SUBJECT: Permit Modification Request for Section 404 Individual Permit and Section 401 Individual Water Quality Certification for the US-74 Monroe Connector/Bypass in Union and Mecklenburg Counties. STIP R-3329 and STIP R-2559, Division 10, Debit WBS Element 34533.1.TA1 in the amount of \$570.

Reference: US Army Corps of Engineers (USACE) 404 Permit issued May 8, 2015; Action ID: SAW-2009-00876
NC Division of Water Resources (NCDWR) 401 Water Quality Certification Permit issued March 6, 2015; NCDWR Project No. 02-0672 V3

PERMIT DRAWINGS
SHEET 183 OF 267
REVISED: 11/16/2015

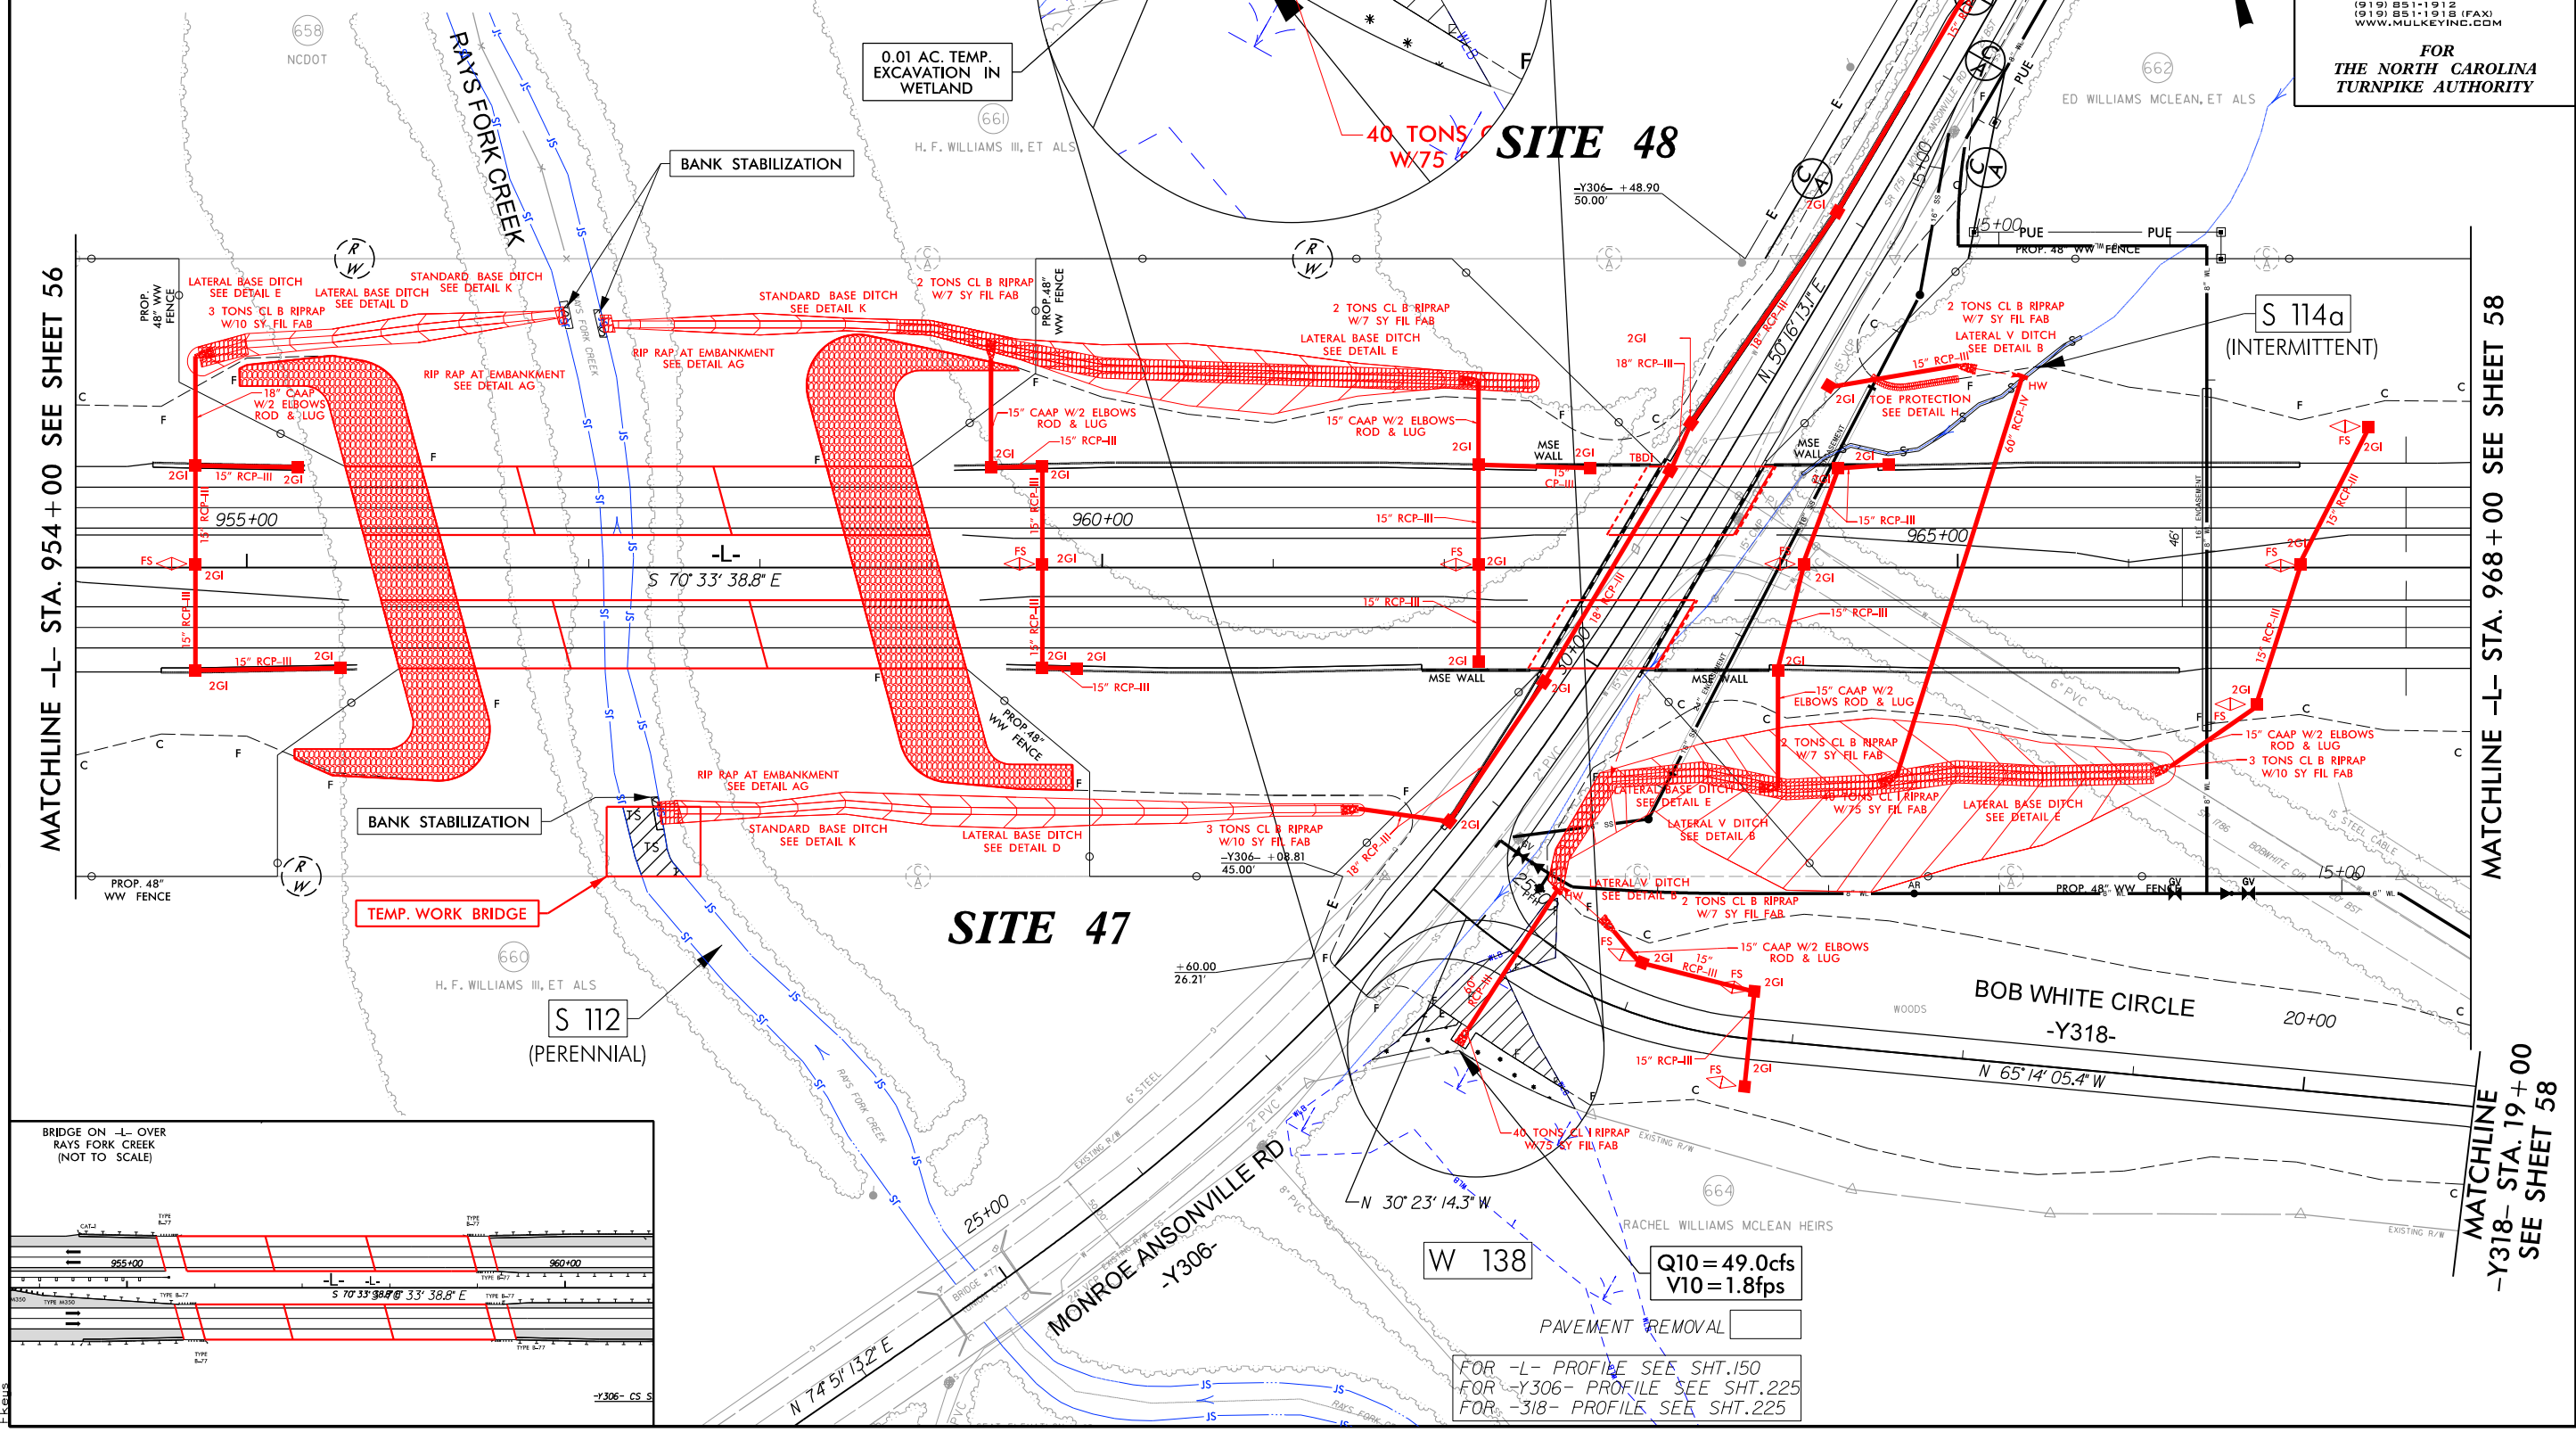
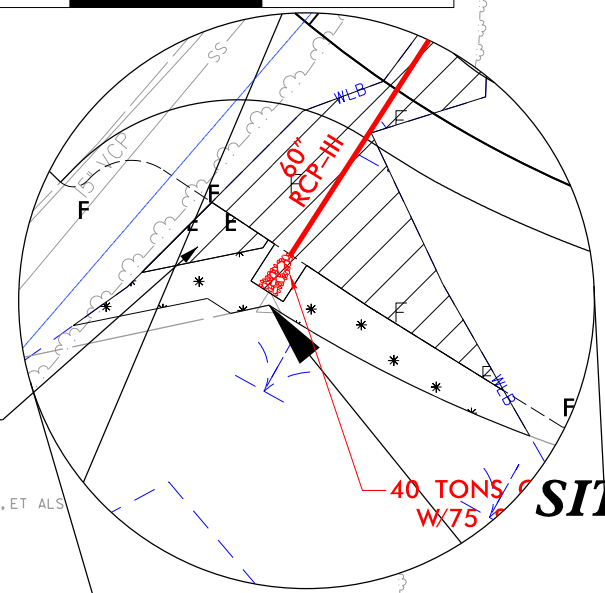
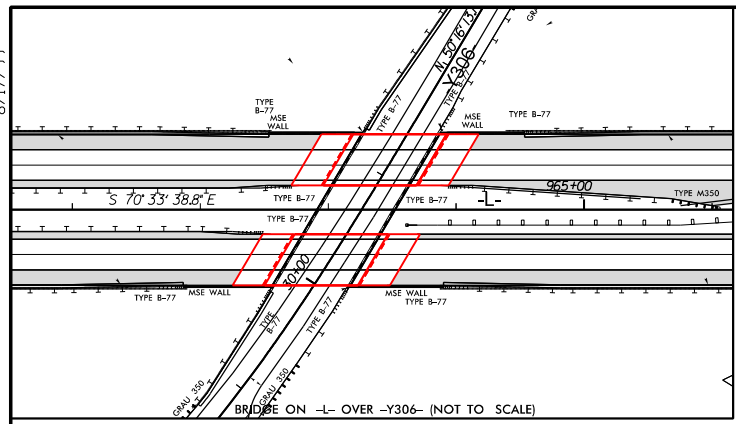
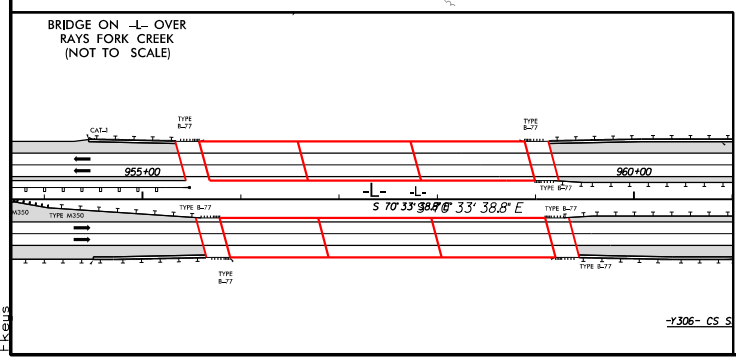
Permit Site 48 (Revised Permit Drawings 183 and 184 of 267):

During the relocation of the sanitary sewer utility, two minor impact revisions are required:

1. The fill slope had to be slightly altered, as such what was initially going to be 0.01 acre of temporary fill became permanent fill, increasing that total from 0.06 to 0.07 acre.
2. There will be 0.01 acre of temporary excavation in wetlands to install the utility line. The area will be revegetated with native vegetation upon completion.

This impact is shown in the blow up on revised permit drawing 183 of 267.

PERMIT DRAWINGS
SHEET 184 OF 267
REVISED: 11/9/2015

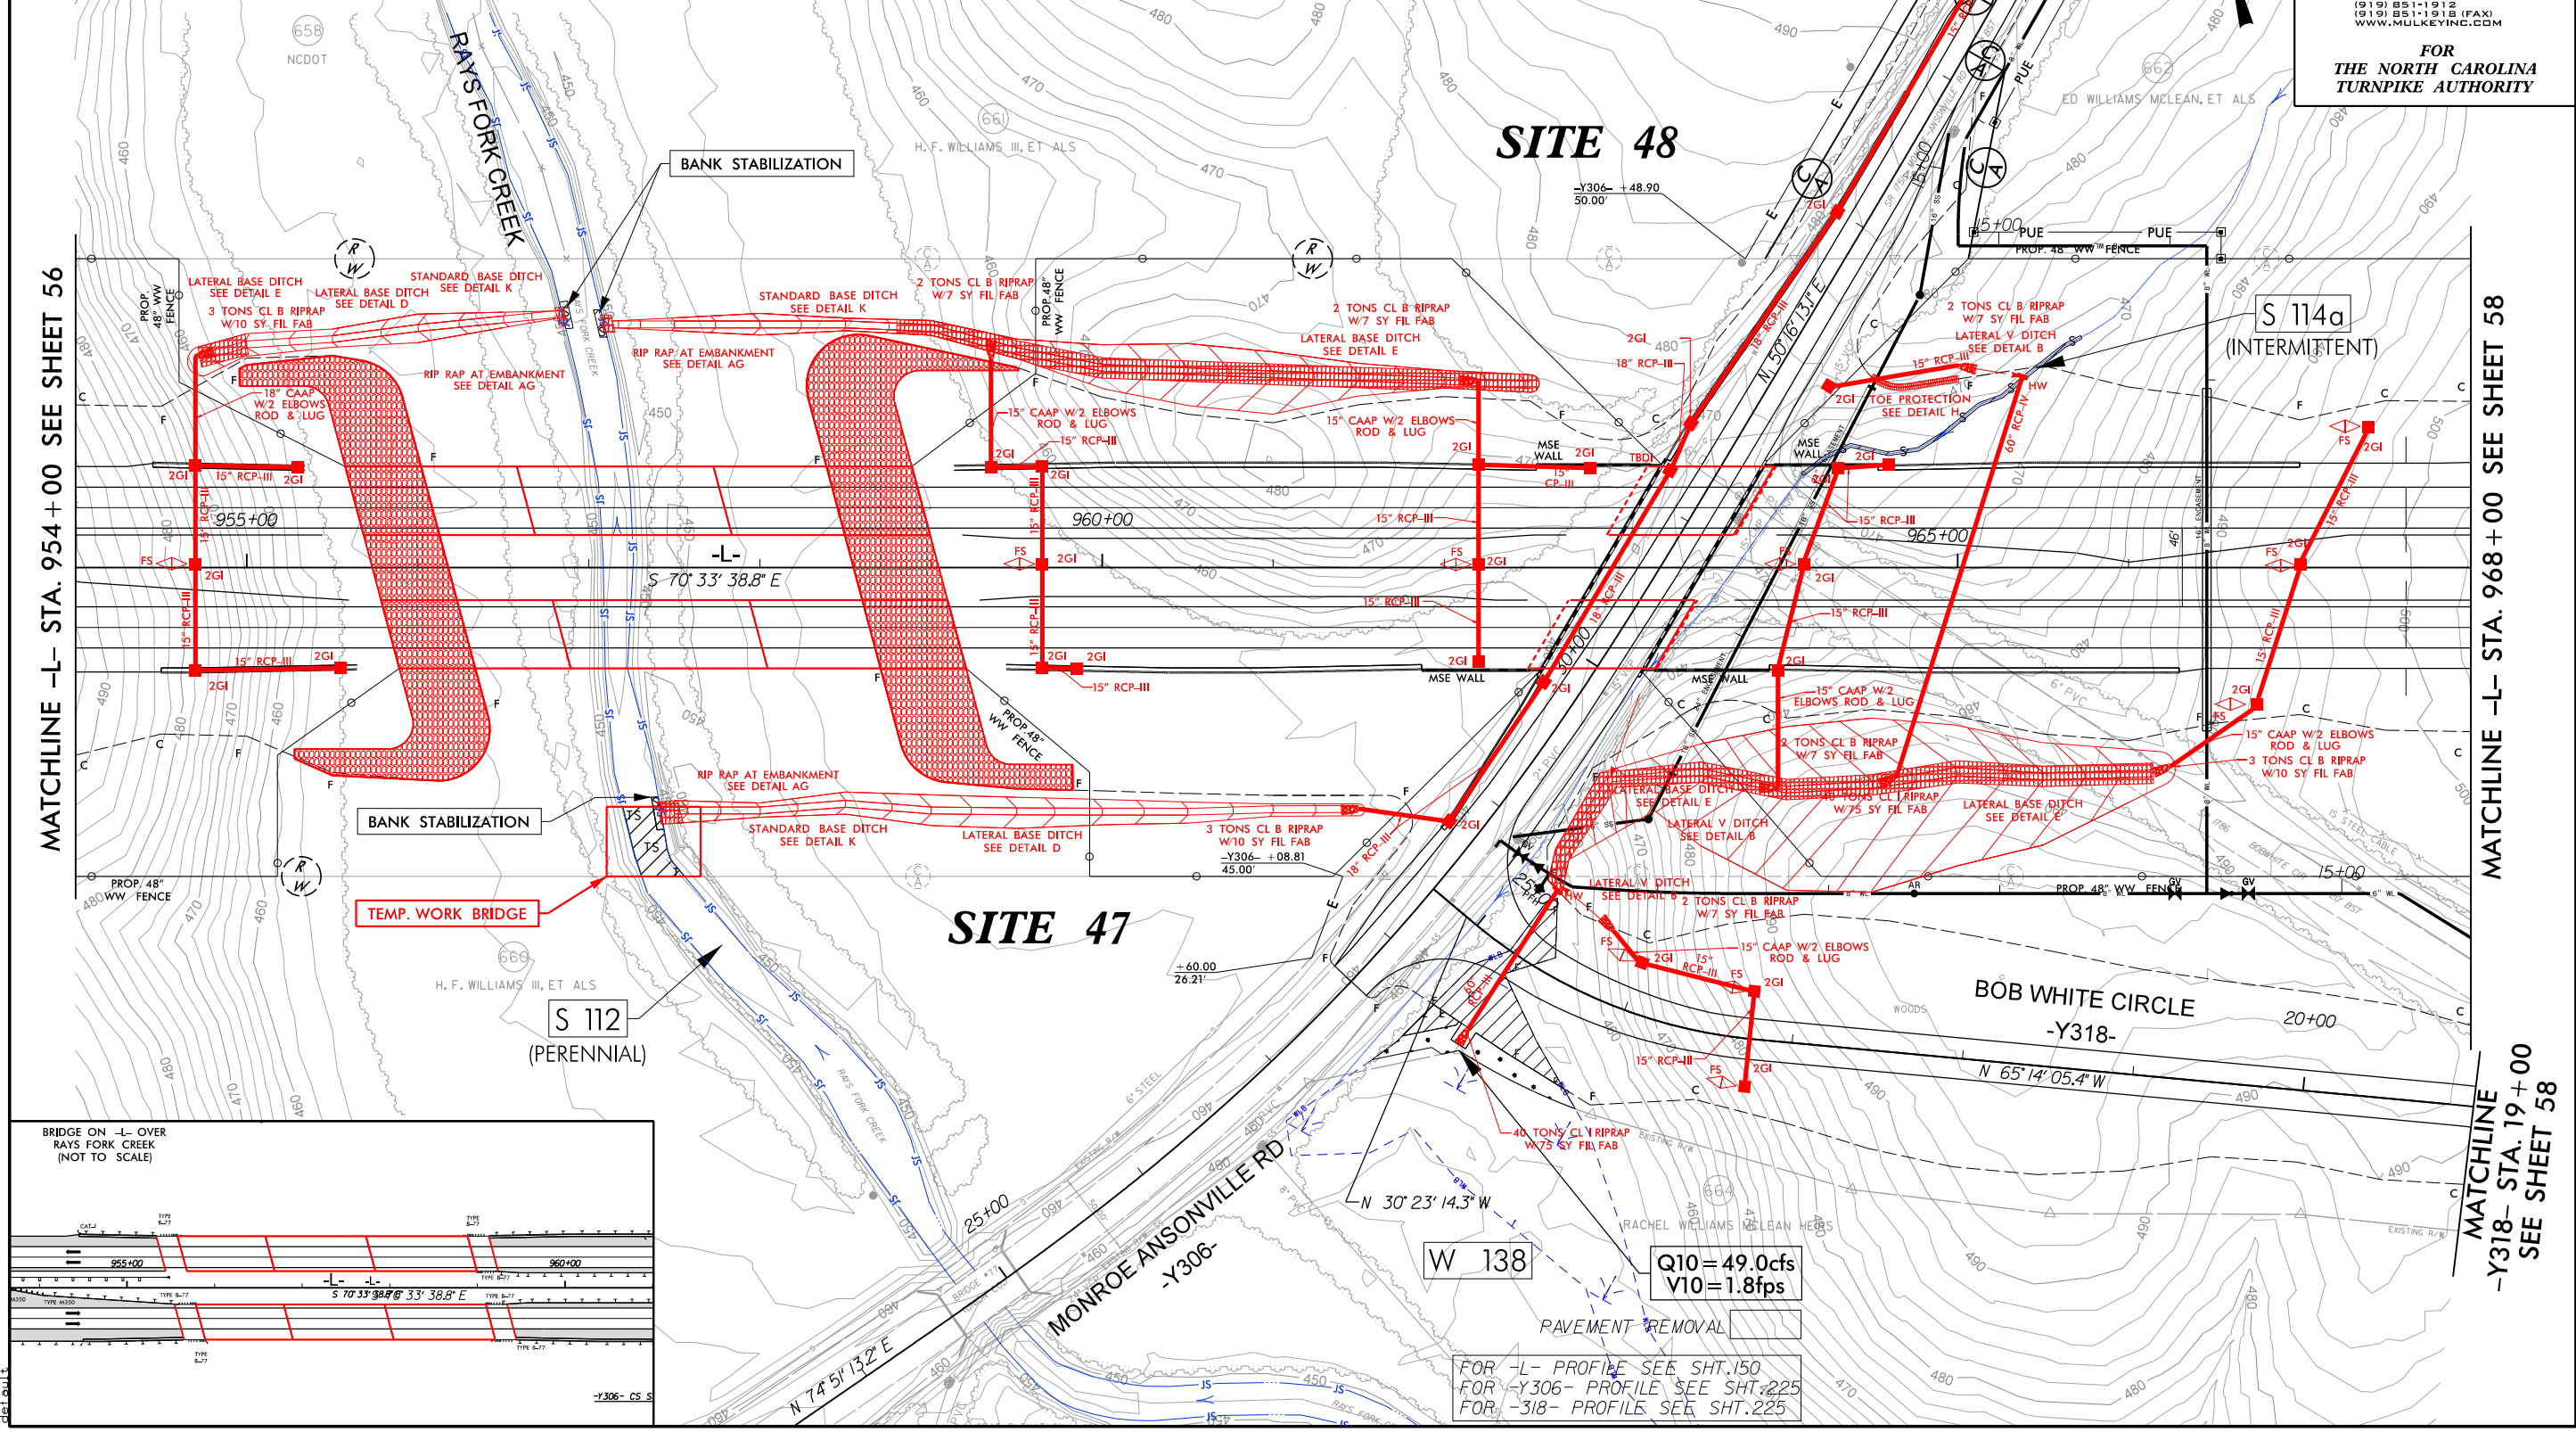
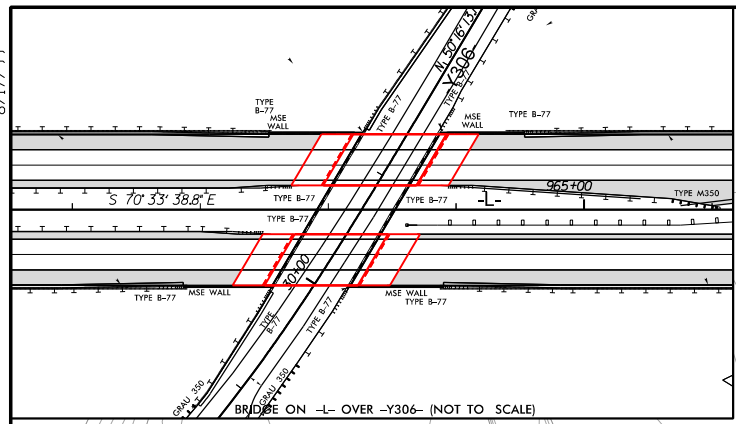
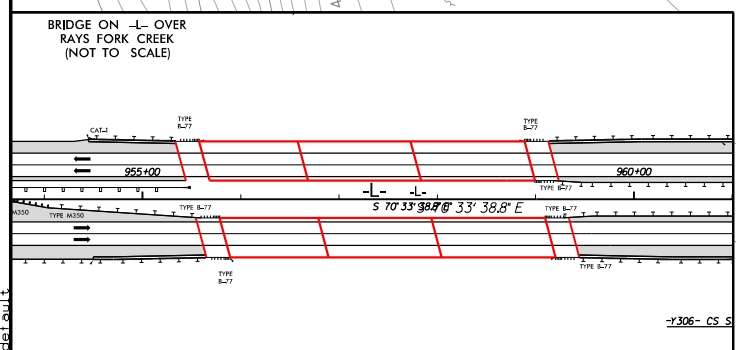
Permit Site 47 (Revised Permit Drawings 183 and 184 of 267):

As you are aware from our correspondence on August 21, 2015, in order to improve construction access, and expedite construction in jurisdictional areas, the contractor has established a temporary bridge crossing of Rays Fork (Permit Site 47). Please note that this was inadvertently referred to as Permit Site 48 in the August 21, 2015 correspondence. The bridge details are attached (60 Foot Standard Temp Bridge Detail).

Impacts to Rays Fork were avoided, as the bridge abutments were kept approximately 10 feet away from the top of bank.

While impacts are still not anticipated, it is requested that 30 linear feet (lf) of temporary stream bank stabilization be authorized in the scenario that stream bank destabilization impacts occur during construction or bridge removal. Any bank stabilization measures will be removed and the area revegetated upon completion of construction.
